Town of Southampton Planning Board
July 7, 2011

AGENDA ITEM No. 7
ADOPTED RESOLUTION
CONDITIONAL APPROVAL
SITE PLAN/SPECIAL EXCEPTION APPLICATION
ENTERPRISE LOT #3, LLC
HAMLET OF RIVERSIDE

SHEET 1 OF 1
SITE PLAN
LOT 3
MAP OF
SOUTHAMPTON ENTERPRISE ZONE
FILE No. 11151 FILED AUGUST 31, 2004
SITUATE
FLANDERS
TOWN OF SOUTHAMPTON
SUFFOLK COUNTY, NEW YORK
S.C. TAX No. 900-141-01-9.5
SCALE 1"=20'
JUNE 5, 2008
JANUARY 28, 2011 ADDED SITE PLAN
APRIL 14, 2011 REVISED MAP
AUGUST 7, 2011 ADDED ADDITIONAL NOTES

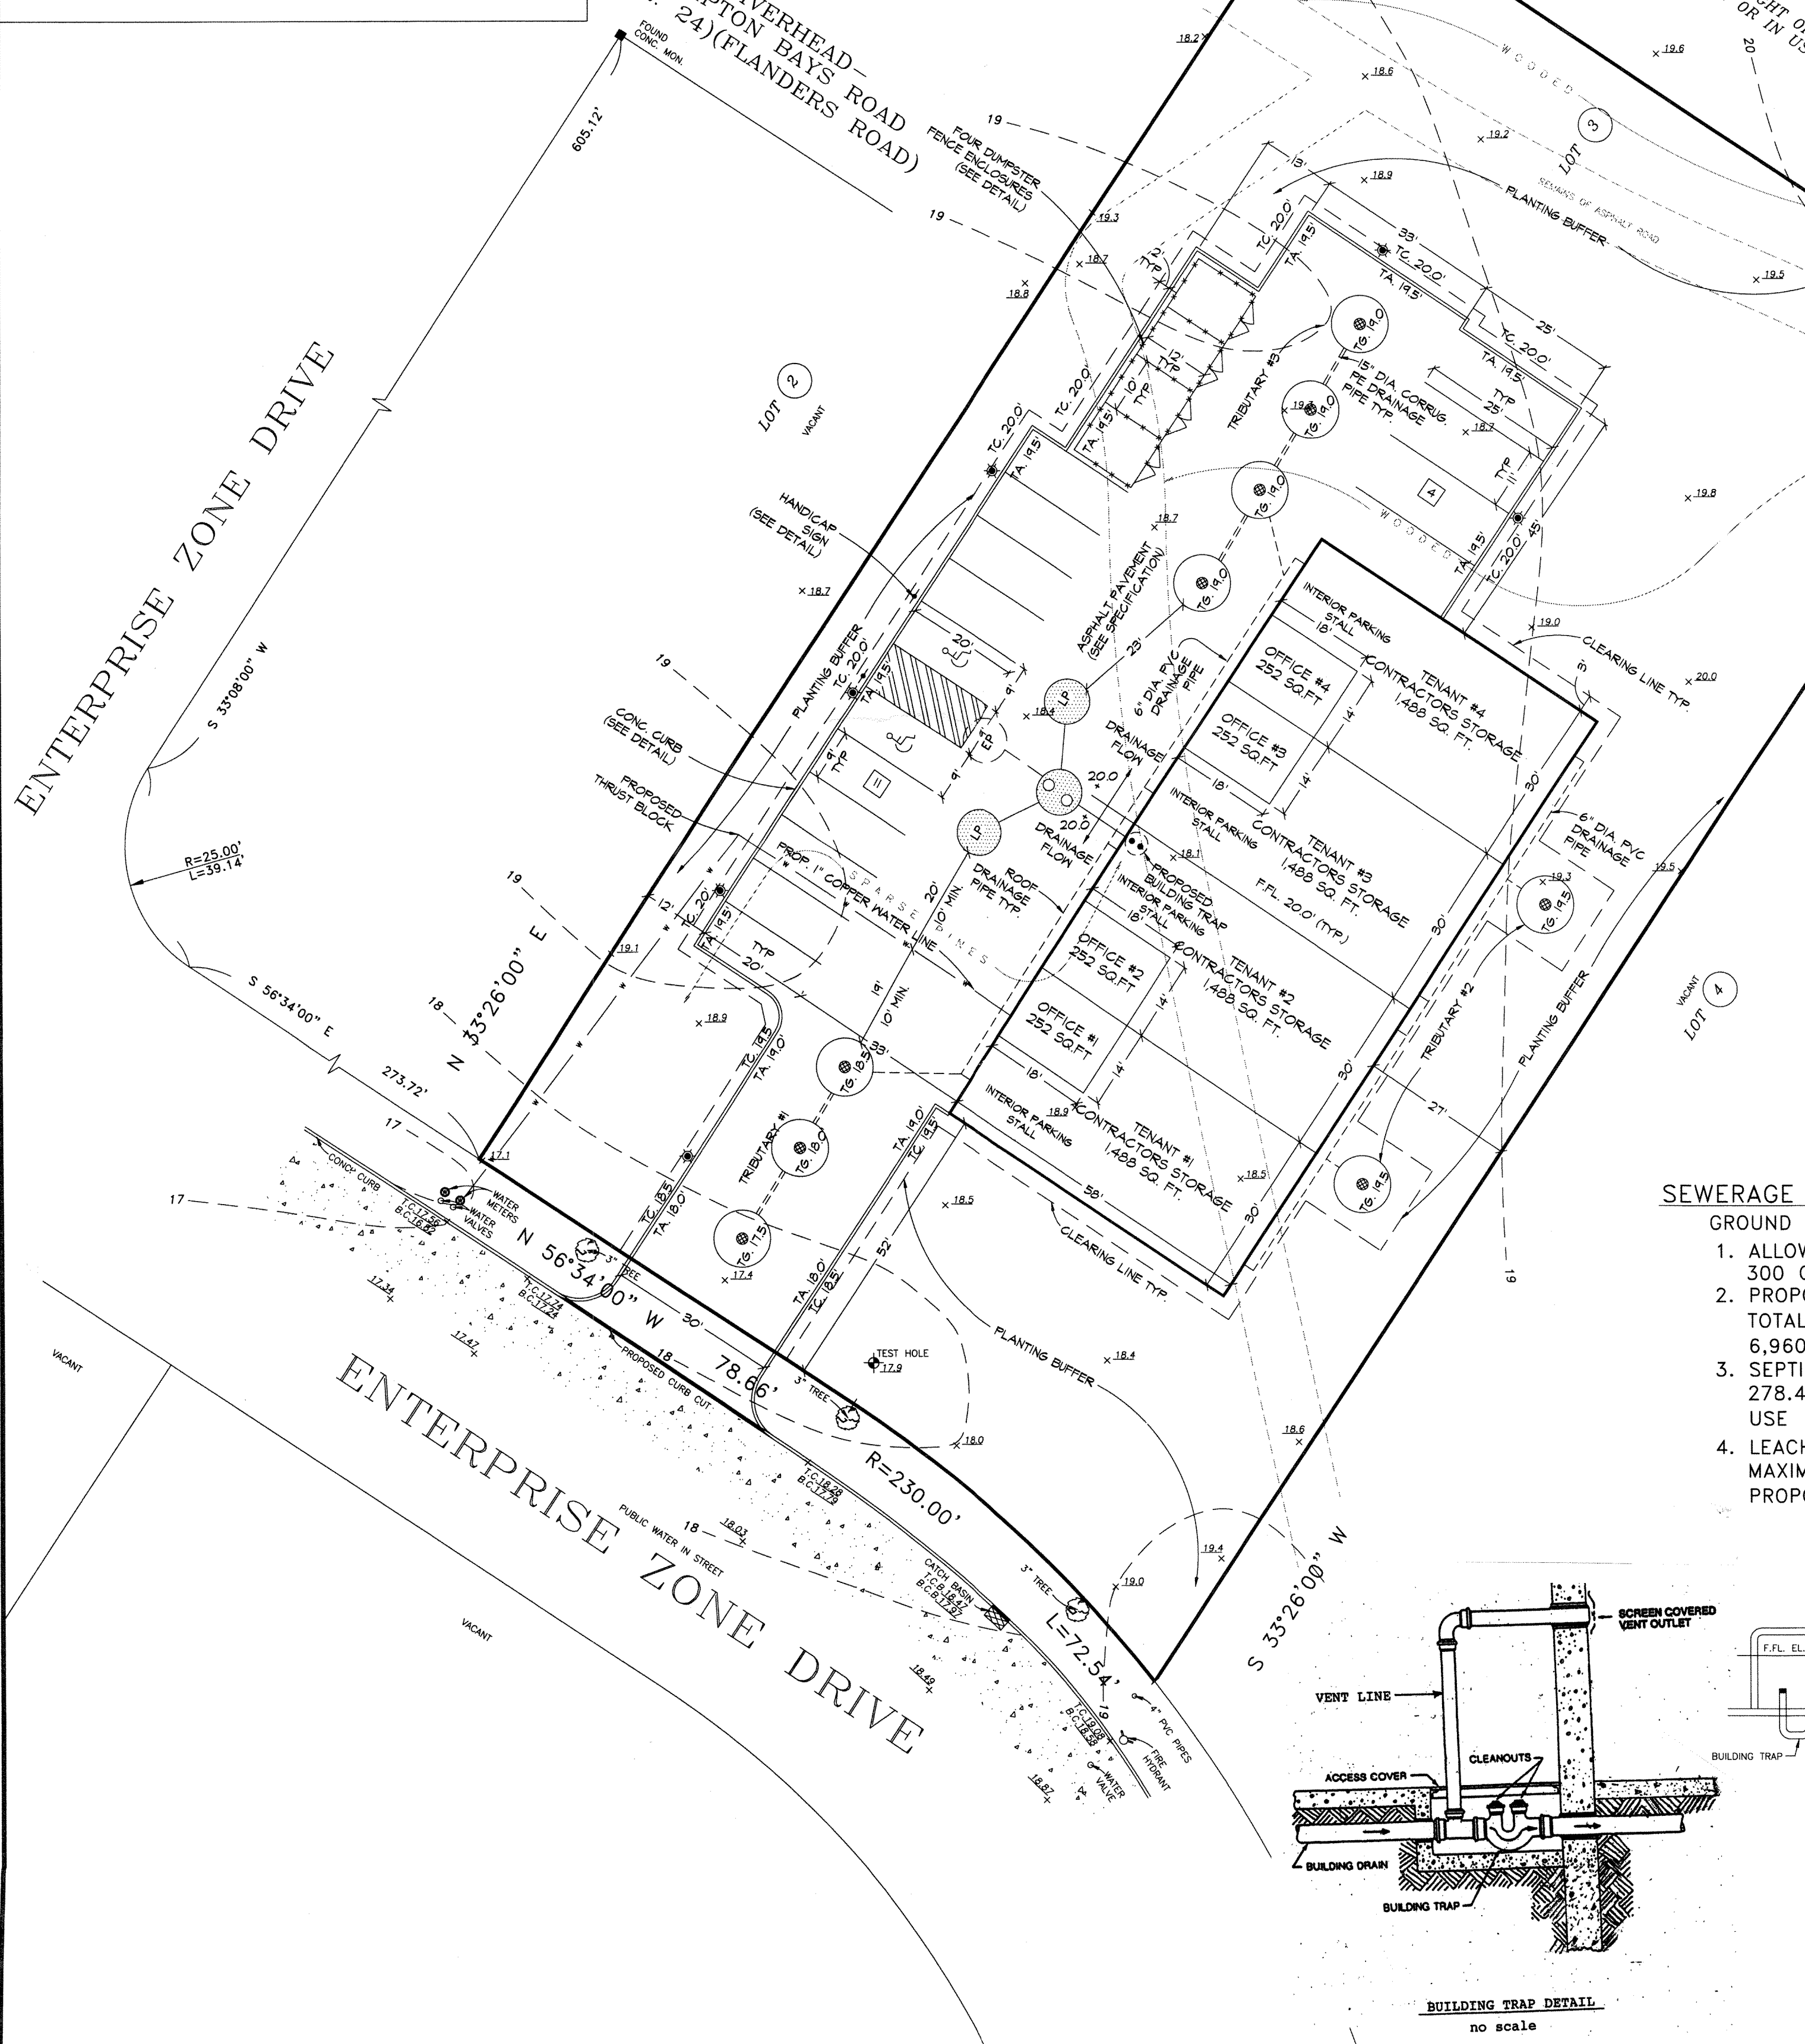
- Indicate 19 required parking spaces.
 - Indicate the parking spaces in each unit.
 - Site plan shall indicate the clearing to be consistent with the landscape plan.

- Compliance with Department of Public Safety comments, including the knock box.
 - Site plan shall note there is a covenant (date of filing) which limits the clearing to 50% of the property and limits fertilization to 15% of the property.

- Indicate use of 15 inch pipe between leaching basins and wrap the upper 4-feet of the leaching basins with filter fabric as per Town standards.
- Landscape Plan to be reviewed by the Environmental Division.
